HISTORIC AND DESIGN REVIEW COMMISSION

February 15, 2017

HDRC CASE NO: 2017-064
ADDRESS: 2619 MCCULLOUGH AVE
LEGAL DESCRIPTION: NCB 1704 BLK 12 LOT N1/2 OF 12 & 13
ZONING: MF-33, H
CITY COUNCIL DIST.: 1
DISTRICT: Monte Vista Historic District
APPLICANT: Curt Labby
OWNER: Benita Zuniga
TYPE OF WORK: Enclose 2nd-story porch
REQUEST:

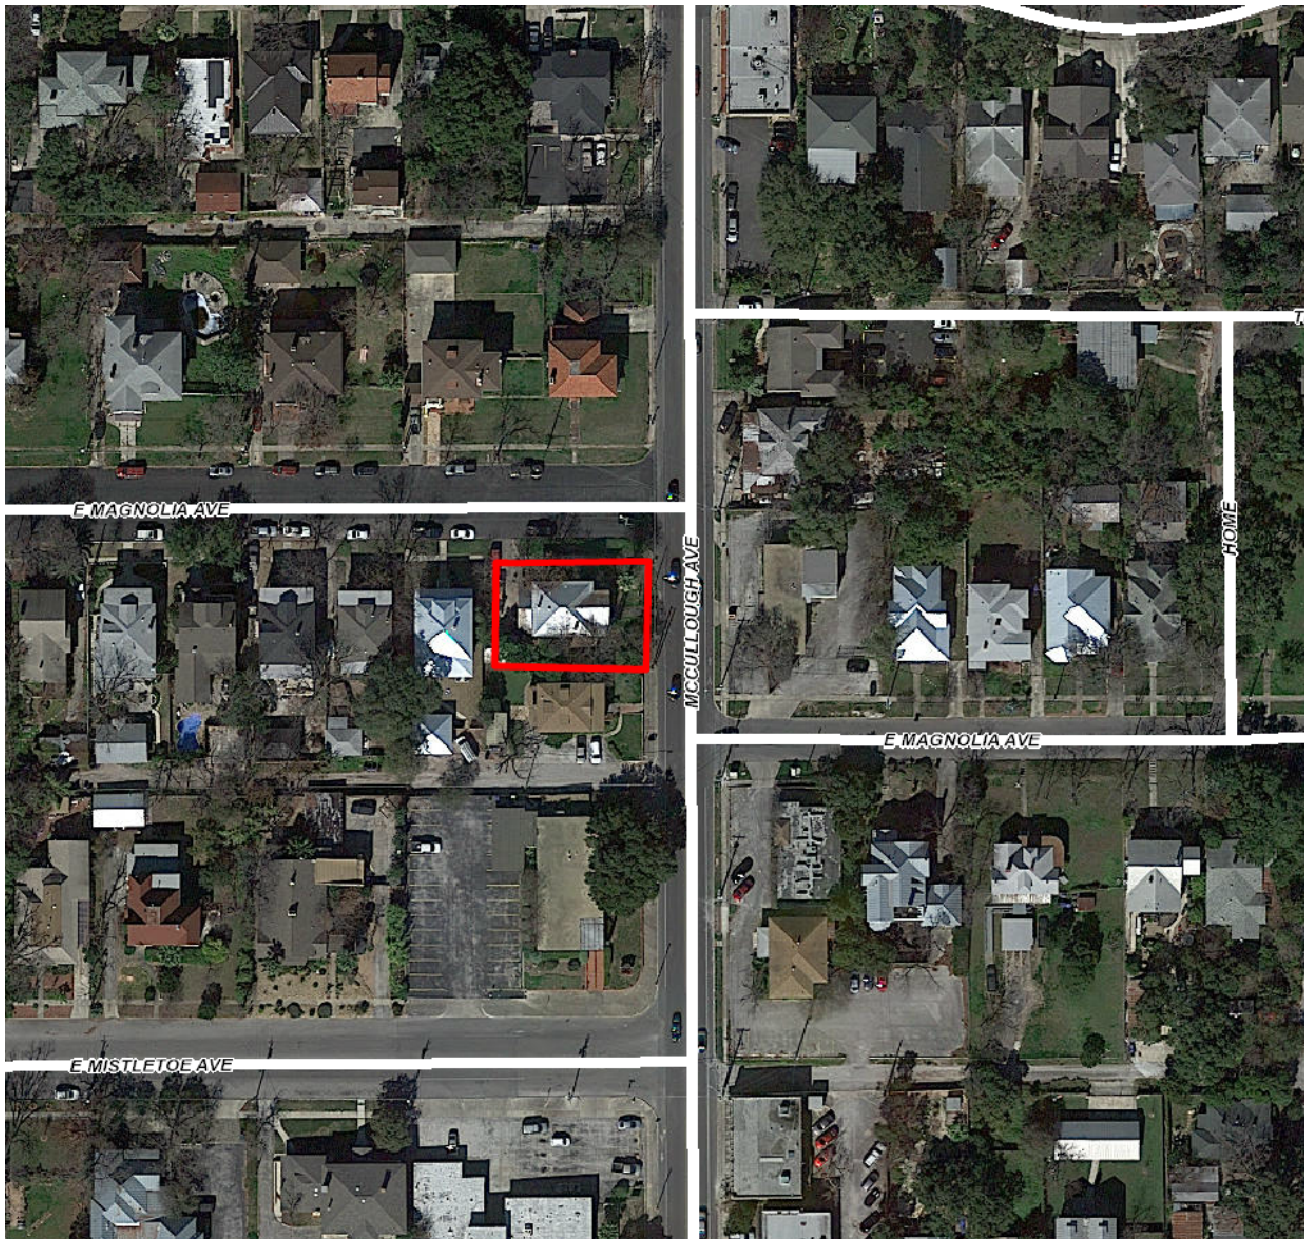
- a. The structure is a two-story craftsman style home built circa 1915. It is a contributing structure in the Monte Vista Historic District, which was designated in 1975.

- b. The 2nd-story has 12 front wood casement windows under the front gable, in the historic, semi-enclosed 2nd-story porch. The proposal includes removing all 12 windows, and encloses the porch with siding to match the existing. Three wood one over one windows are proposed on the front 2nd-story façade. According to the Guidelines for Exterior Maintenance and Alterations 7.B.i, do not enclose front porches, and screen panels should not change the character of the historic structure. Staff finds the proposal is not consistent with the Guidelines.

- c. There are 3 rear wood one over one windows that have clear glass. The proposal is to front the existing glass. According to the Guidelines for Exterior Maintenance and Alterations 6, and the Guidelines for Windows, historic windows feature clear glass. Staff finds the proposal appropriate as the work is reversible.

Staff recommends approval of item #3 based on finding c. Staff does not recommend approval of items #1 and #2 based on findings a and b. Staff recommends the windows be retained.

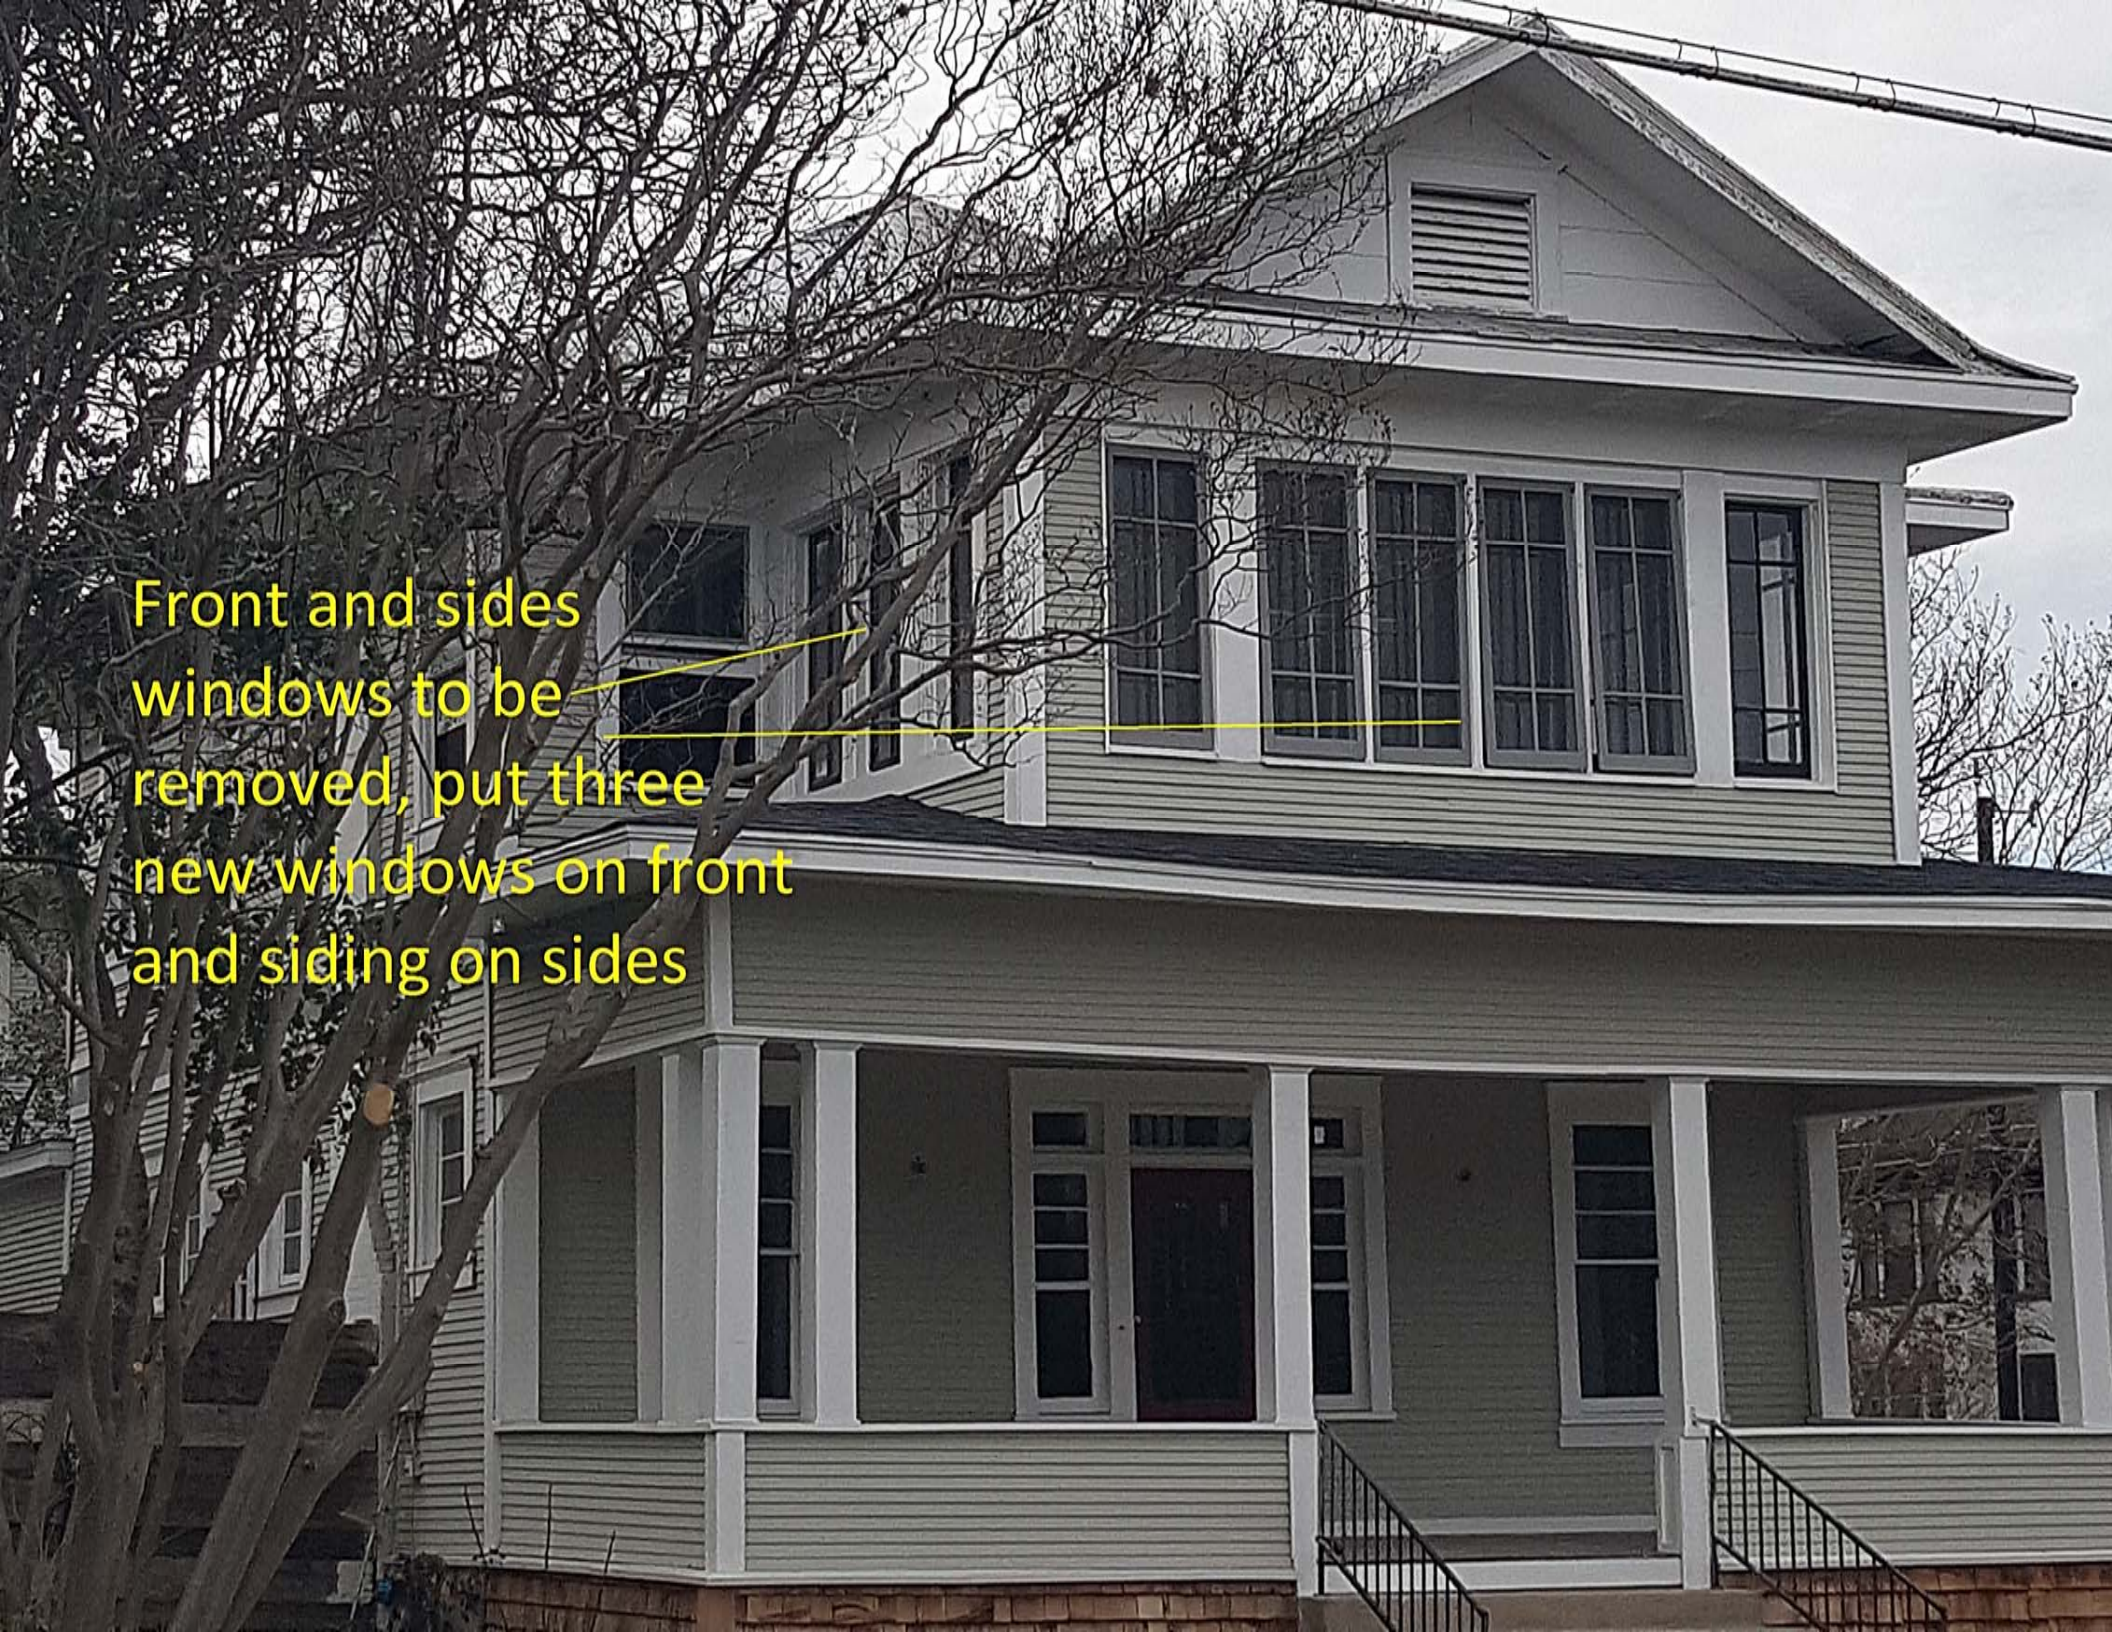
Front and sides
windows to be
removed, put three
new windows on front
and siding on sides

FROST 3 REAR
WINDOWS

Remove this
windows and
leaving only three
new windows

inset 2-3 inches
3 wood replacement
windows
same dimensions
as below

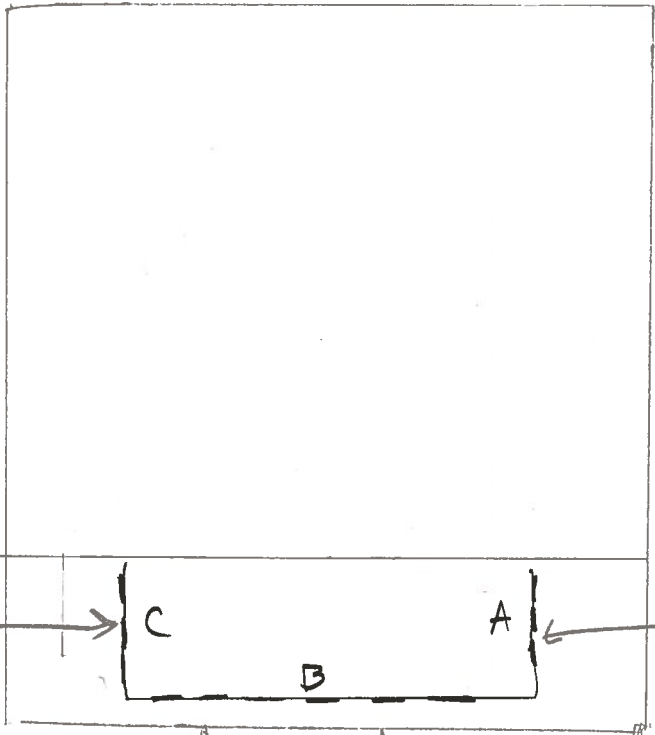
steel casement
A, B, C to be
removed,
enclosed

enclosed
siding to match
existing
